REMARKS

This is a full and timely response to the outstanding final Office Action (Paper No. 15) mailed February 6, 2004. Claims 5, 6, 9, 12, 13, 15 - 19, and 22 have been cancelled in previous amendments without prejudice, waiver, or disclaimer. Claims 4 and 11 are canceled in this amendment without prejudice, waiver, or disclaimer. Claims 1 and 7 have been amended. The subject matter of amended claims 1 and 7 is contained within FIGs. 5 - 13 and the related detailed description of the specification. Consequently, no new matter has been added to the application.

In re Colon-Bonet Serial No.: 09/501.045

ANNOTATED DRAWING SHEET

FIG. 5

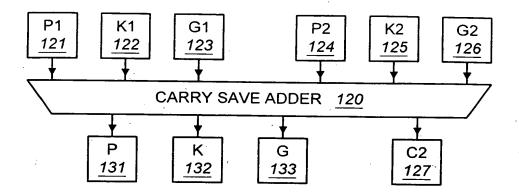
FIG. 5 has been amended to correct column labels. The corrected labels in the table of FIG. 5 correspond to respective values generated by the carry-save adder illustrated in FIG. 4. Accordingly, no new matter has been introduced to the application.
